**CITY OF TEMPE
DEVELOPMENT REVIEW COMMISSION**

Meeting Date: 08/25/2015
Agenda Item: 5

BACKGROUND INFORMATION: **BROADSTONE LAKESIDE (PL150188)** is a proposed four-story, mixed-use development containing 168 dwelling units and 2,053 square feet of co-work office space. AN AFFIRMATIVE VOTE BY AT LEAST TWO-THIRDS (2/3) OF THE CITY COUNCIL IS REQUIRED TO APPROVE THE GENERAL PLAN DENSITY MAP AMENDMENT. The request includes the following:

Due to the timing of revisions provided by the applicant, missing information, and many discrepancies found among the submitted items, staff is recommending a continuance.

DATE: AUGUST 03, 2015 ORB # 14-214
A1.10
SITE PLAN
PRELIMINARY

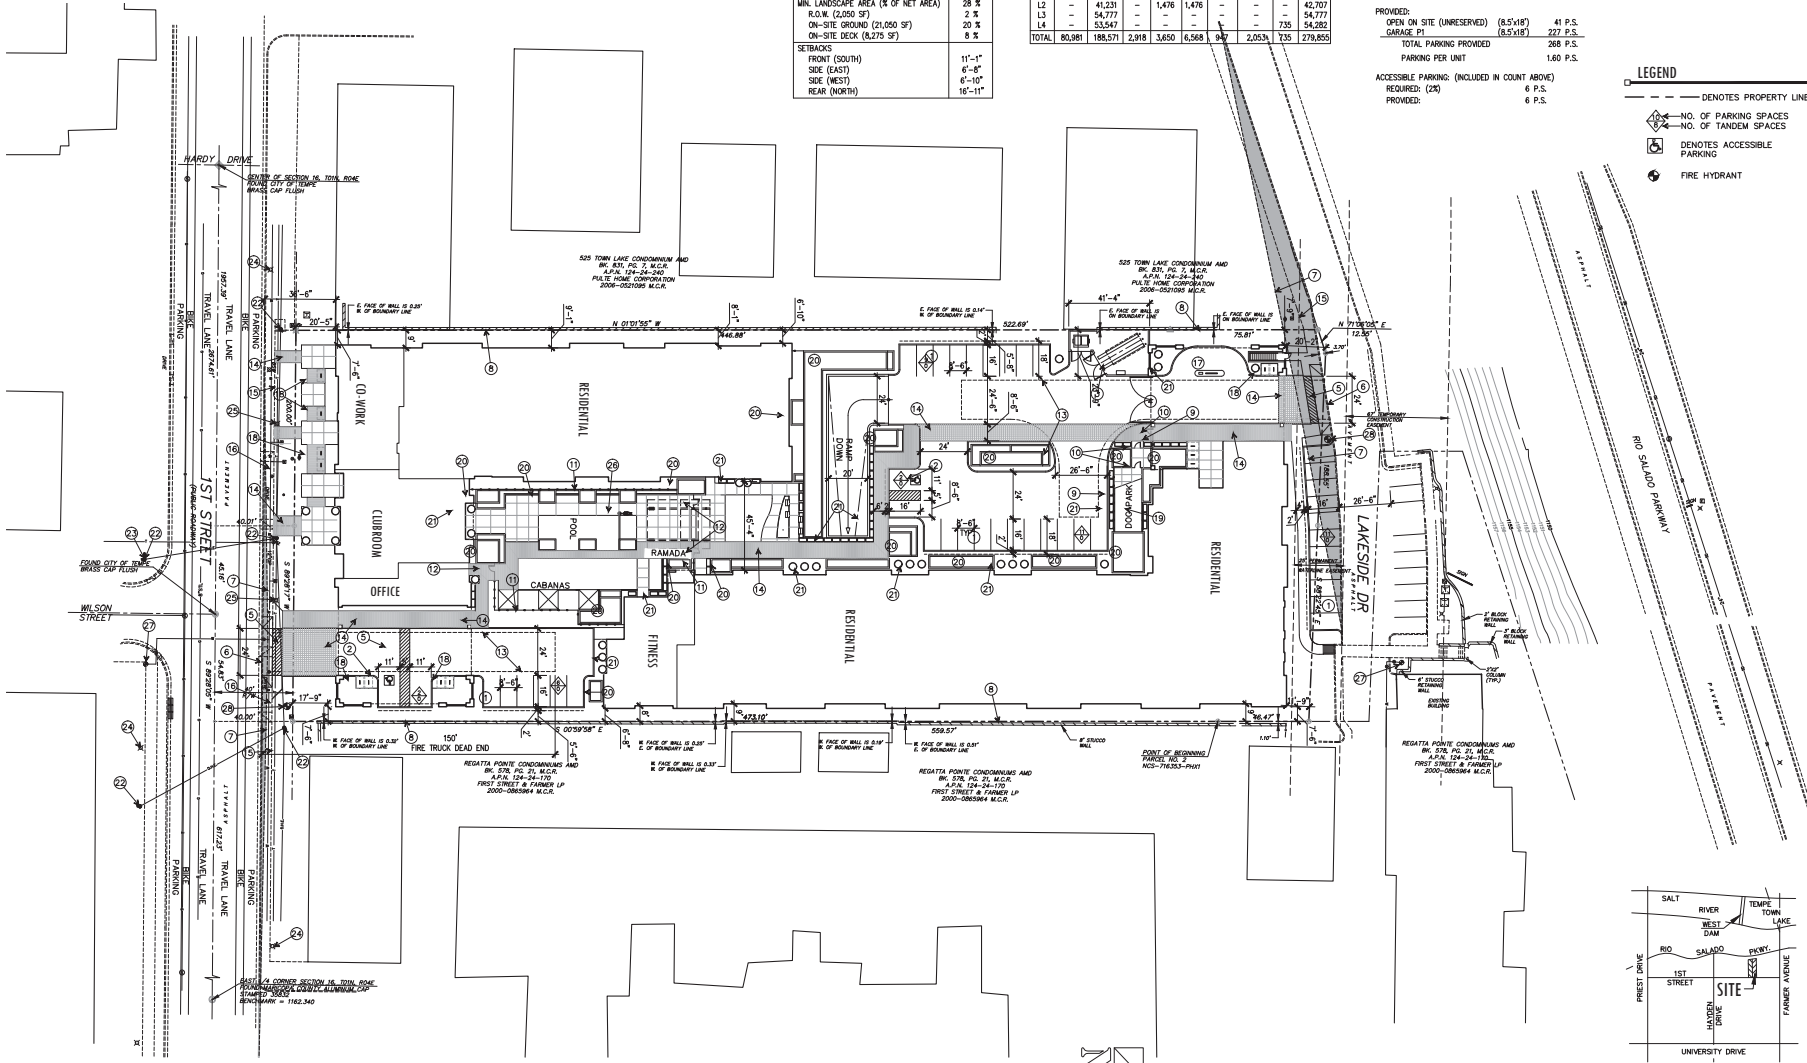
Discrepancies exist with the building setbacks noted within letter of explanation, the project data tables, and the revised site plan (received August 6, 2015). The letter of explanation and data tables note the south setback as 11'-1" and the north setback as 16'-11". The site plan identifies a south setback of 20'-5" and a north setback of 11'-9". Staff supports a 20'-5" south setback; however, the revised north setback places the dwelling units closer to the proposed sidewalk and vehicle parking spaces, resulting in a minimum separation between sleeping area and sidewalk of approximately 4' and between sleeping area and parking spaces of approximately 10'. ZDC Section 4-503.E, Design and Construction Standards for Pathways and Access Ways, requires that pathways be separated a minimum of 10' from sleeping areas on the ground floor to provide privacy. Staff recommends a condition to require a minimum 10' separation between the sidewalk and sleeping area of the units and a minimum 14' separation between parking spaces and sleeping area. This could be addressed by either modifying the floor plan/unit plan to locate non-livable areas along the north end of the building or shifting/eliminating the units closest to the sidewalk and parking.

2. Provide a minimum 10' separation between the sidewalk and sleeping area of the units and a minimum 14' separation between parking spaces and sleeping area.

3. Add a landscape island near the center of the row of 11 parking spaces in the north surface parking lot. The island shall comply with ZDC Section 4-704.C.

4. Remove the landscape island in the center of the north parking lot to allow clear fire access. Alternatives may be approved by the Fire Department.
5. Provide a fire hydrant in the vicinity of the refuse enclosure. If a hydrant is provided in the landscape island south of the enclosure, the island must be modified to permit room for a hydrant and required landscaping. Final hydrant location shall be approved by the Fire Department.

6. Indicate on the site plan and garage floor plan the number of bicycle parking spaces provided in each area where bicycle racks are identified on the plans. Additional bicycle parking shall be provided interior to the building, either in a common bike parking area(s) or within individual units in order to comply with the required number of spaces.

NORTH ELEVATION

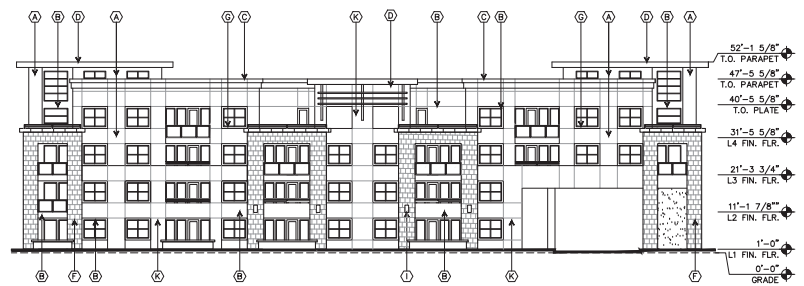
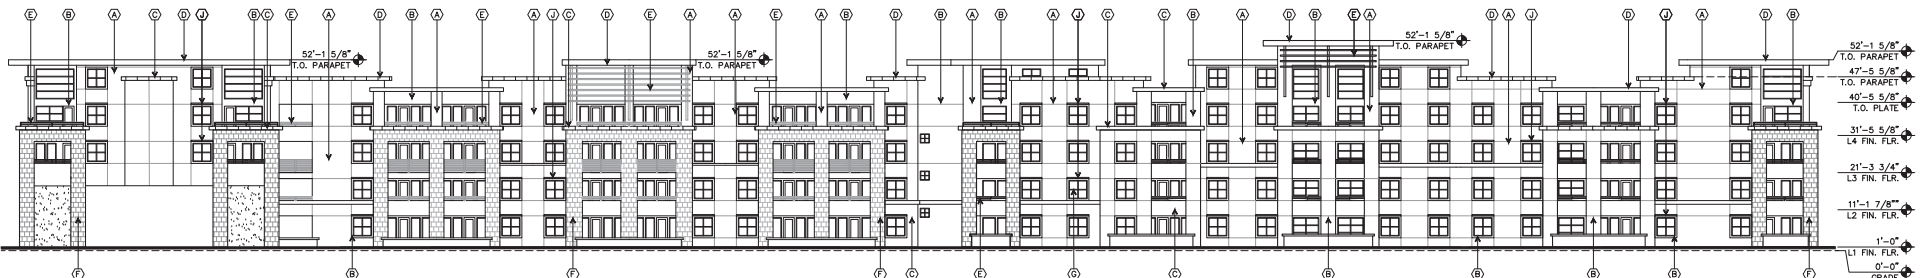
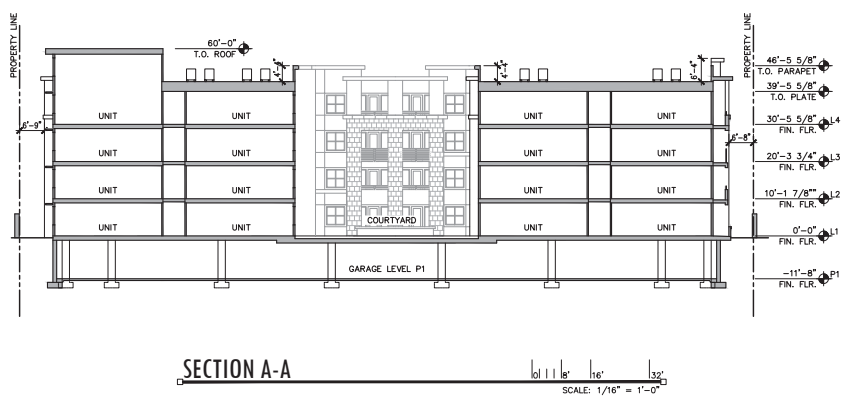
the most recent elevations (received August 10, 2015), and the building sections. These show 60', 57'-4", and 60', respectively. The applicant should revise the elevations and sections to match.

15. Identify the third, medium gray, stucco color shown on the east and west elevations.
16. Glass panels at balconies shall be laminated.
17. The property owner shall replace the wood panels on the north and south elevations when weathering occurs. Replacement shall be like-for-like or, with approval of a Development Plan Review, another approved material.
18. Provide secure roof access from the interior of the building. Do not expose roof access to public view.
19. Conceal roof drainage system within the interior of the building.

LS.10
 LANDSCAPE PLAN
 PRELIMINARY

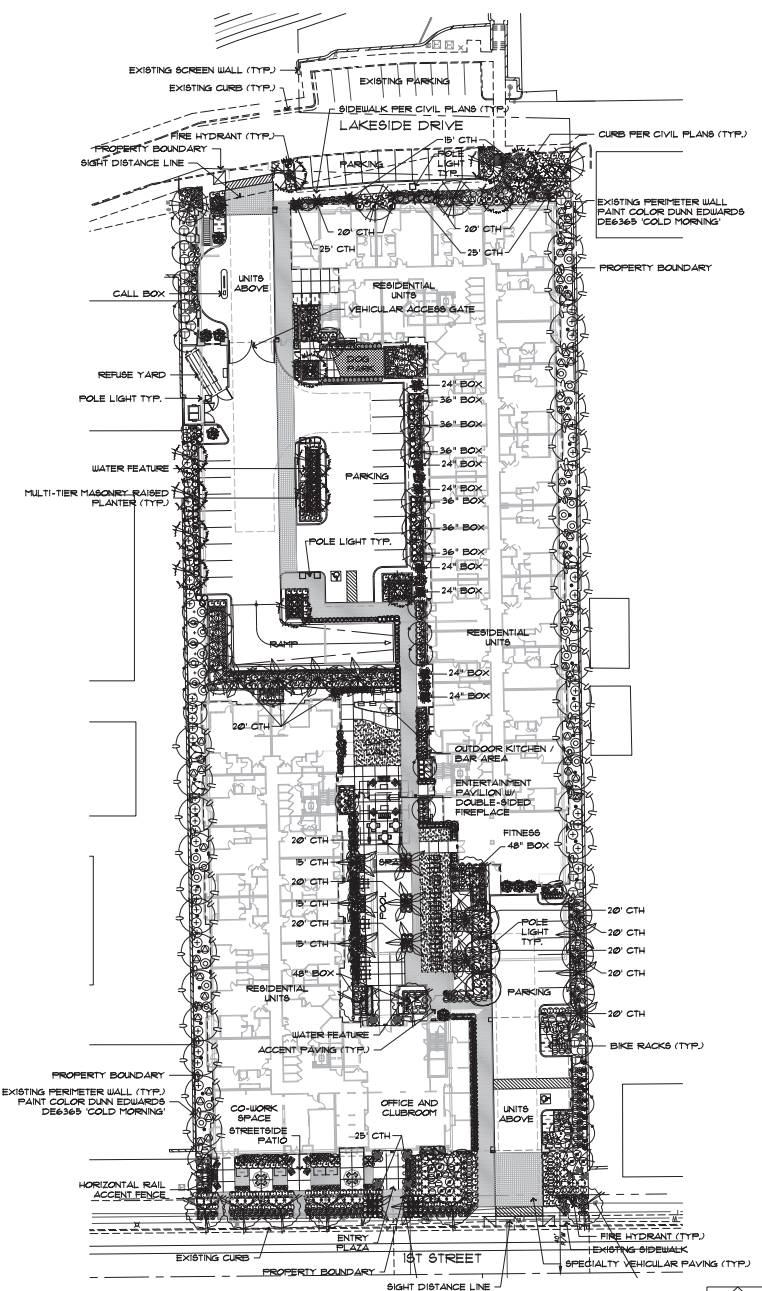
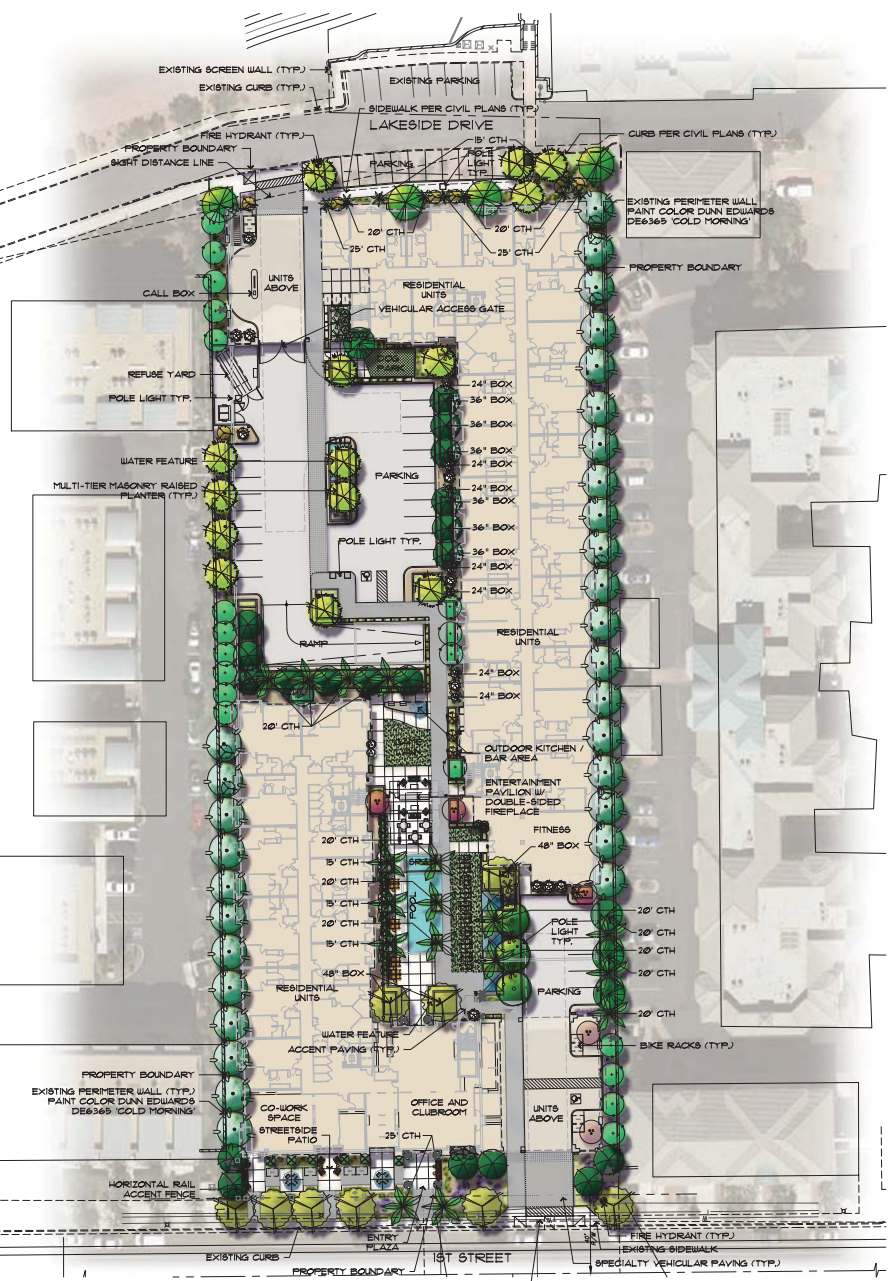
26. Irrigation notes:
 - a. Provide dedicated landscape water meter.
 - b. Provide pipe distribution system of buried rigid (polyvinylchloride), not flexible (polyethylene). Use of schedule 40 PVC mainline and class 315 PVC ½" feeder line is acceptable. Class 200 PVC feeder line may be used for sizes greater than ½". Provide details of water distribution system.

27. Include requirement to de-compact soil in planting areas on site and in public right of way and remove construction debris from planting areas prior to landscape installation.

28. Top dress planting areas with a rock or decomposed granite application. Provide rock or decomposed granite of 2" uniform thickness. Provide pre-emergence weed control application and do not underlay rock or decomposed granite application with plastic.

29. Trees shall be planted a minimum of 20'-0" from any existing or proposed public water or sewer lines. The tree planting separation requirements may be reduced from the waterline upon the installation of a linear root barrier, a minimum of 6'-0" parallel from the waterline, or around the tree. The root barrier shall be a continuous material, a minimum of 0.08" thick, installed 0'-2" above finish grade to a depth of 8'-0" below grade. Final approval subject to determination by the Public Works, Water Utilities Division.
